22/0537/OUT Land At St Bridget Nursery Old Rydon Lane Exeter Devon EX2 7JY

The Exeter Cycling Campaign welcomes the opportunity to comment on the outline proposal for [land at St.Bridget Nursery, Old Rydon Lane.](#)

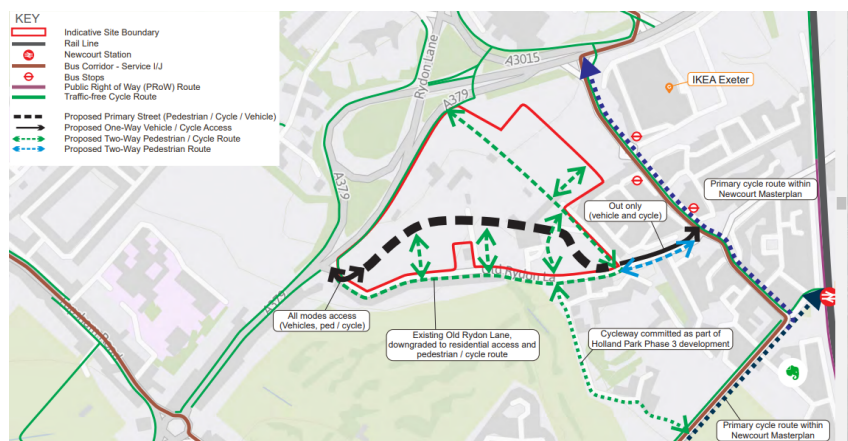
We would ask that the access/egress points from the development for people cycling is clarified/confirmed. Our reading of the different maps/diagrams in the Design and Access Statement and the Transport Assessment implied slightly different access points. For example:

Para 3.2.5 states:
“Running north south across the site are 3 green routes providing a good level of permeability and connections to Rydon Lane and the cycleway”.
The Transport Assessment maps these out in this figure.
